| Project Title: | Lafayette Backup Generating Facility |
| Document Title: | LBGF Updated FAA No Hazard Determinations |

Aeronautical Study No.
2020-AWP-12505-OE

**** DETERMINATION OF NO HAZARD TO AIR NAVIGATION ****

TOPO Map for ASN 2020-AWP-12505-OE

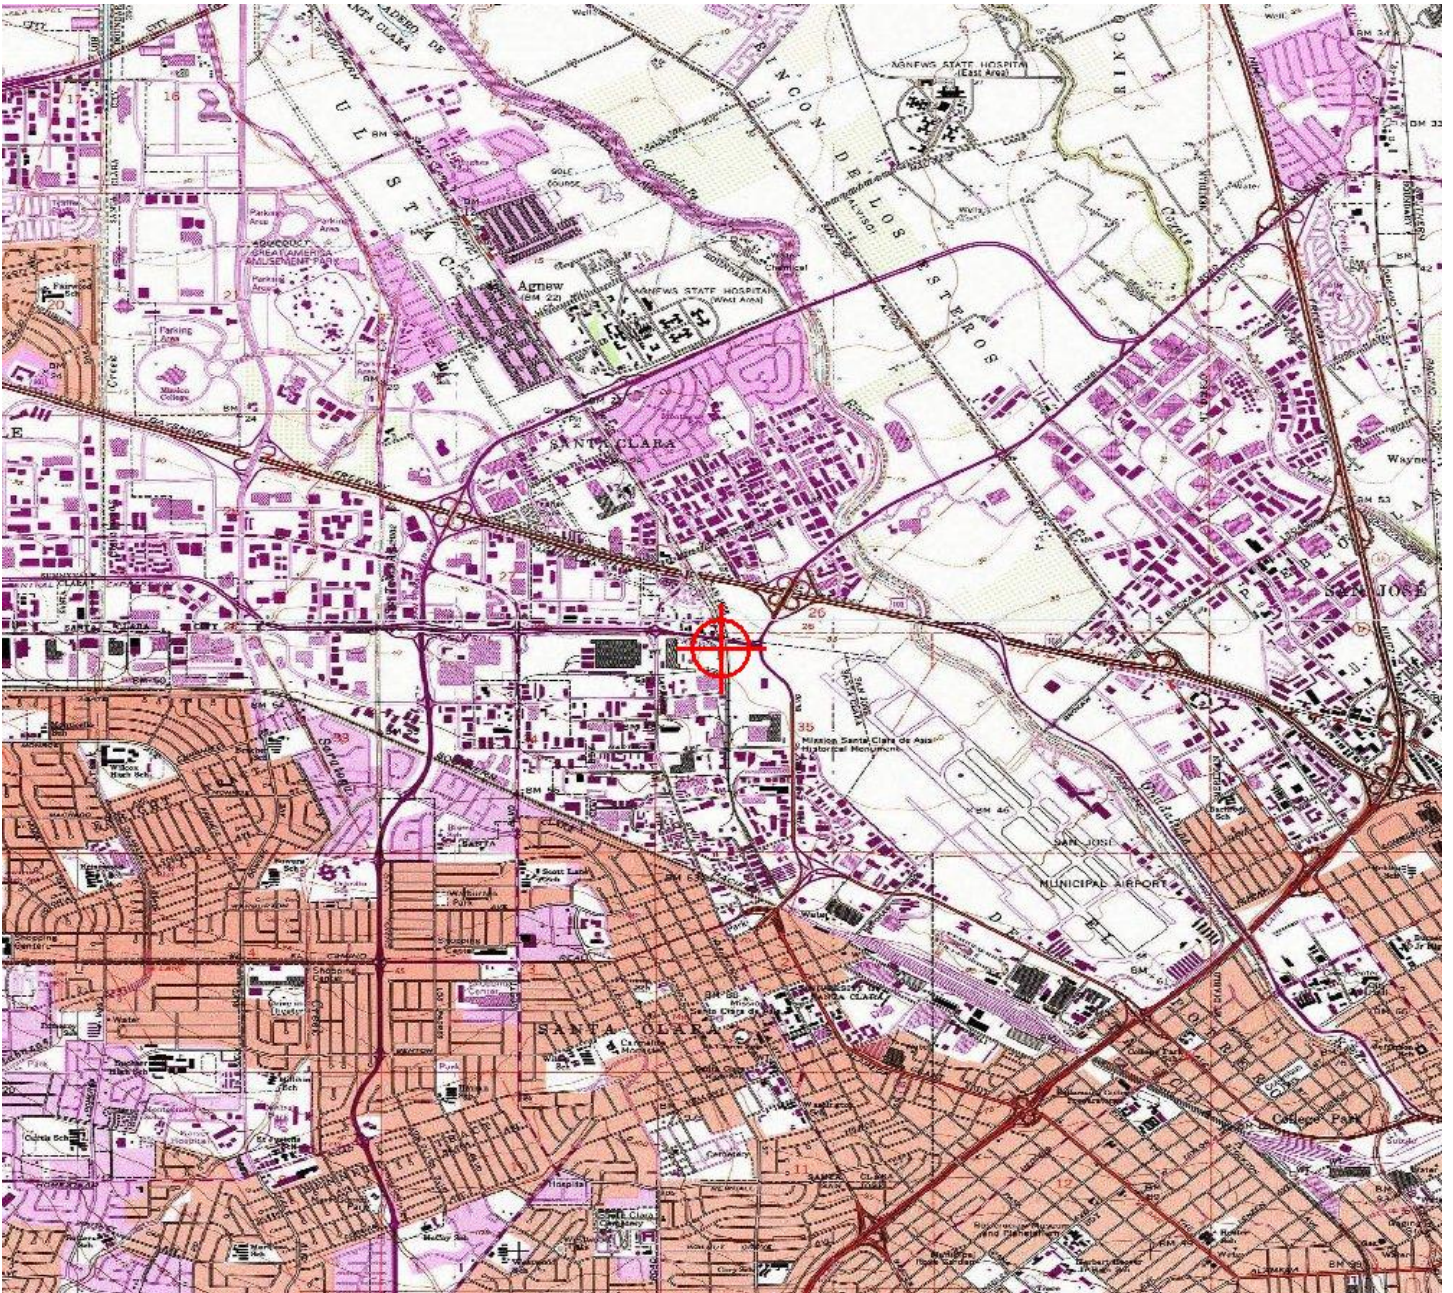
This building will be located in very close proximity to the threshold of the Norman Y. Mineta San Jose International Airport (SJC) Runway (RWY) 12R. Occupants and people outside the building will be exposed to frequent loud jet aircraft noise and the sight of large commercial aircraft operating at very low altitudes near the building.

TOPO Map for ASN 2020-AWP-12506-OE

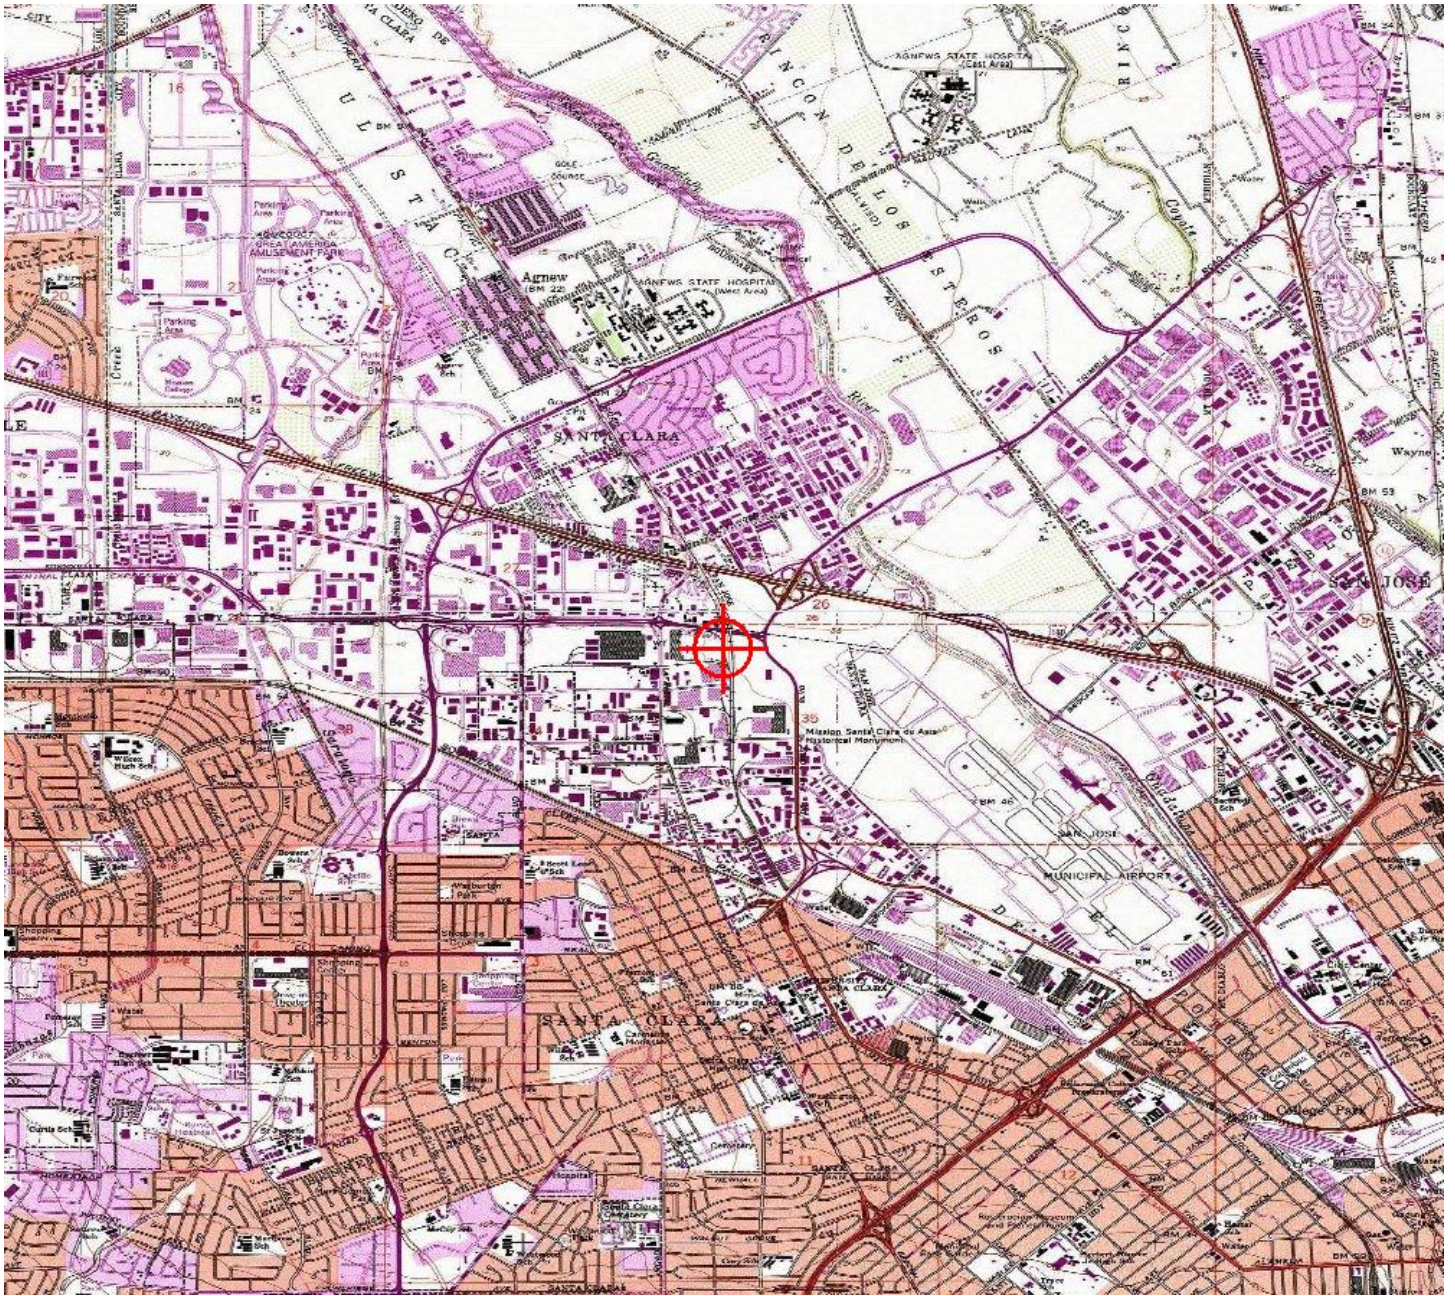
This building will be located in very close proximity to the threshold of the Norman Y. Mineta San Jose International Airport (SJC) Runway (RWY) 12R. Occupants and people outside the building will be exposed to frequent loud jet aircraft noise and the sight of large commercial aircraft operating at very low altitudes near the building.

Additional information for ASN 2020-AWP-12507-OE

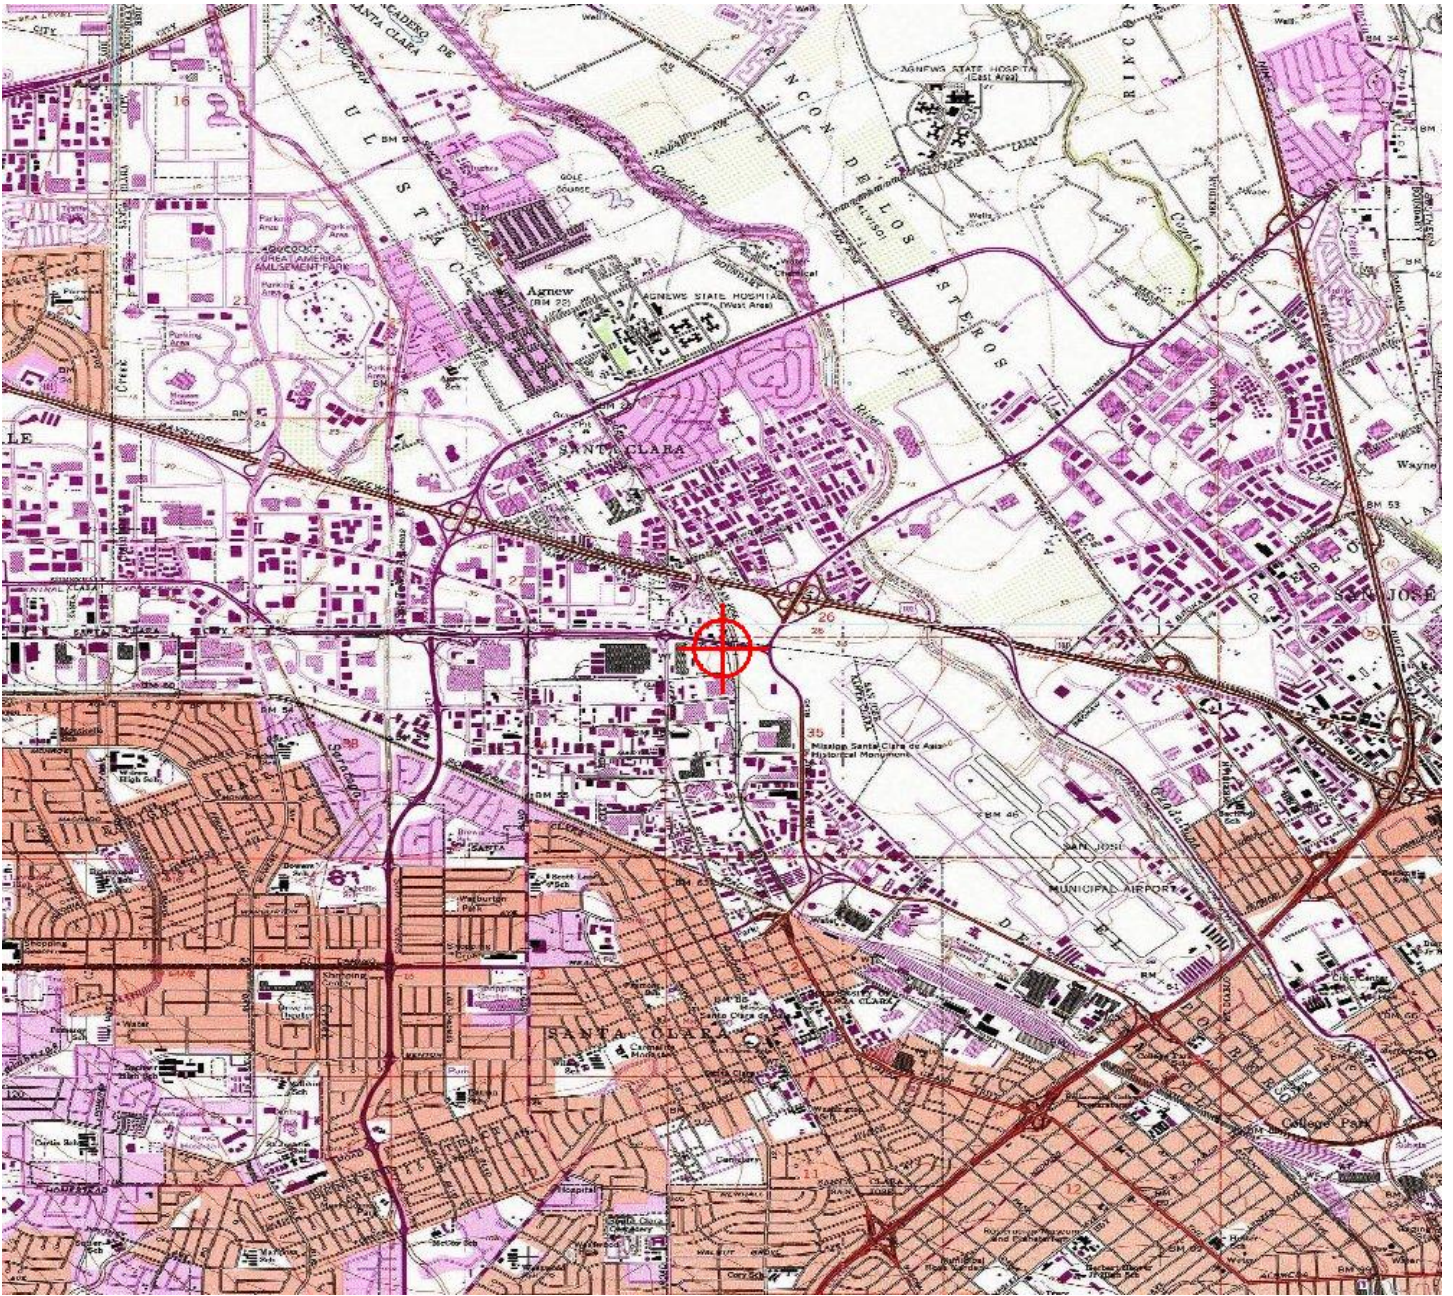
Any height exceeding 83 feet above ground level (124 feet above mean sea level), will result in a substantial adverse effect and would warrant a Determination of Hazard to Air Navigation.

At the negotiated reduced height of 83 feet above ground level (AGL), 124 feet above mean sea level (AMSL), this corner of the building will be at the exact height of the Norman Y. Mineta San Jose International Airport (SJC) Runway (RWY) 12R/30L 14 CFR Part 77 transitional surface. At any height greater than 83 feet AGL/124 feet AMSL, this corner of the building would require circularization for public comment and red obstruction lighting.

Additional information for ASN 2020-AWP-12508-OE

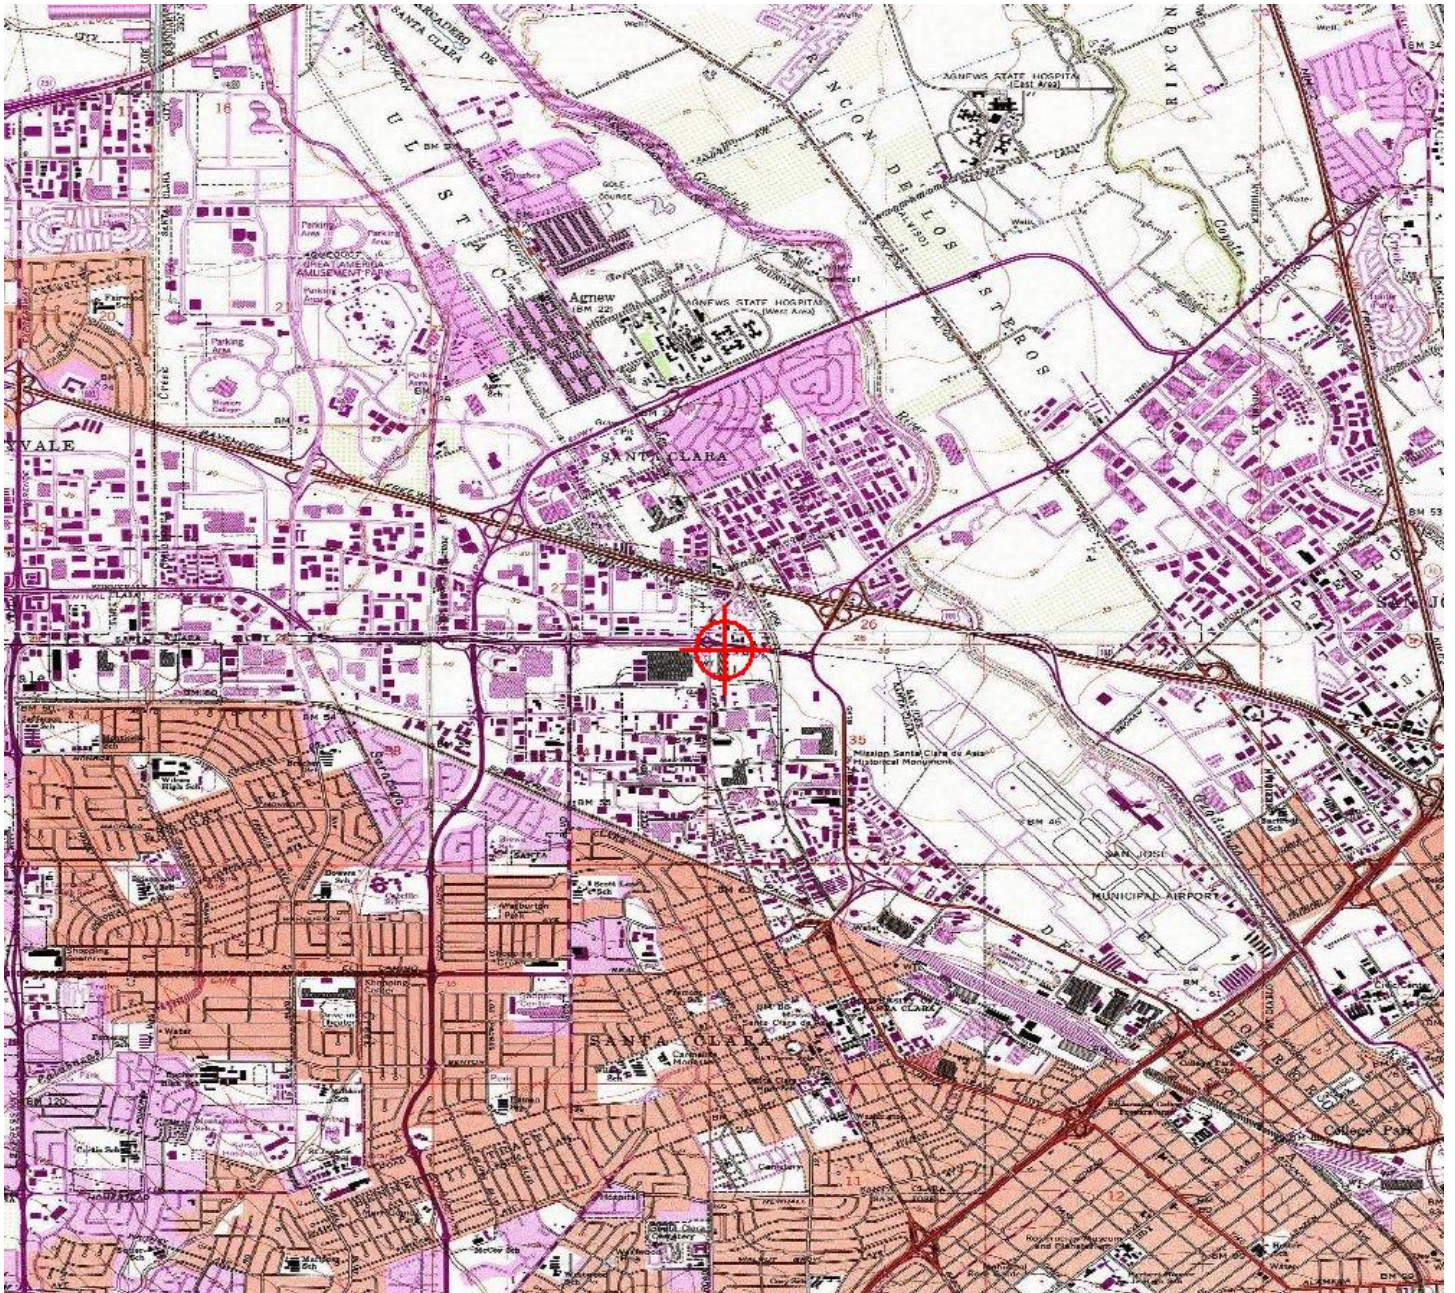
This building will be located in very close proximity to the threshold of the Norman Y. Mineta San Jose International Airport (SJC) Runway (RWY) 12R. Occupants and people outside the building will be exposed to frequent loud jet aircraft noise and the sight of large commercial aircraft operating at very low altitudes near the building.

Additional information for ASN 2020-AWP-12509-OE

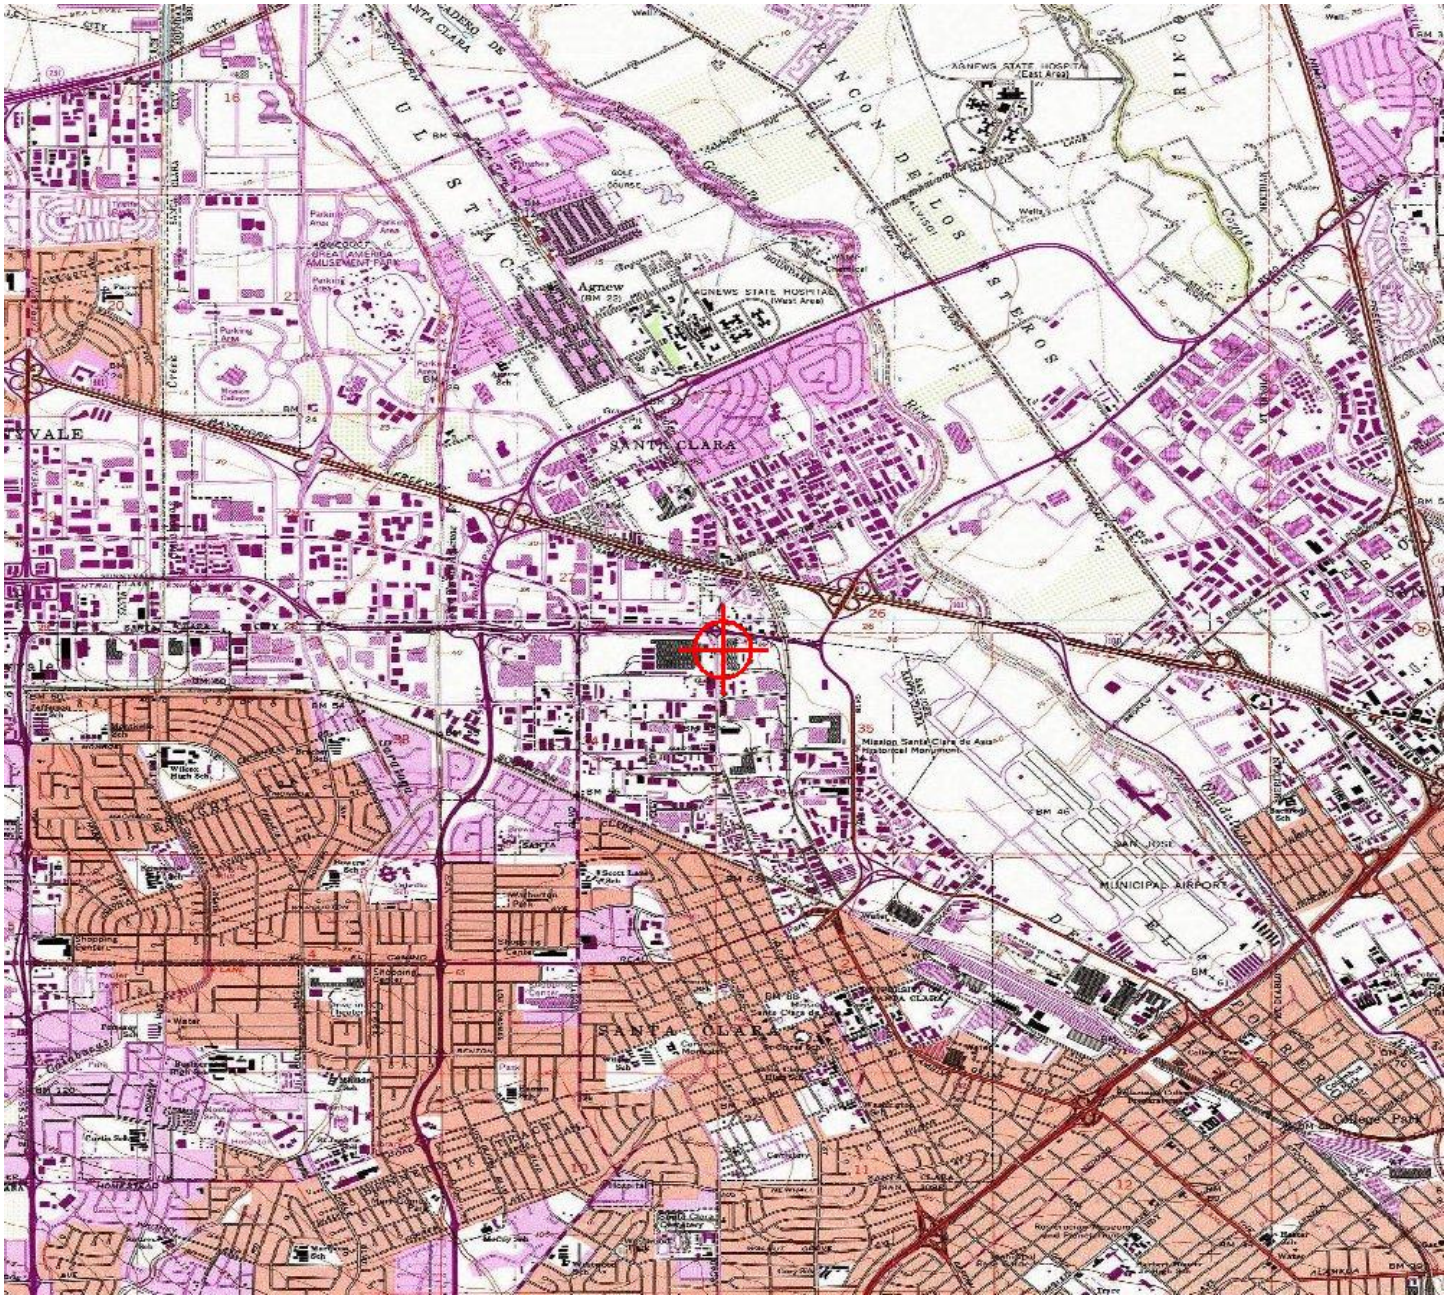
This building will be located in very close proximity to the threshold of the Norman Y. Mineta San Jose International Airport (SJC) Runway (RWY) 12R. Occupants and people outside the building will be exposed to frequent loud jet aircraft noise and the sight of large commercial aircraft operating at very low altitudes near the building.
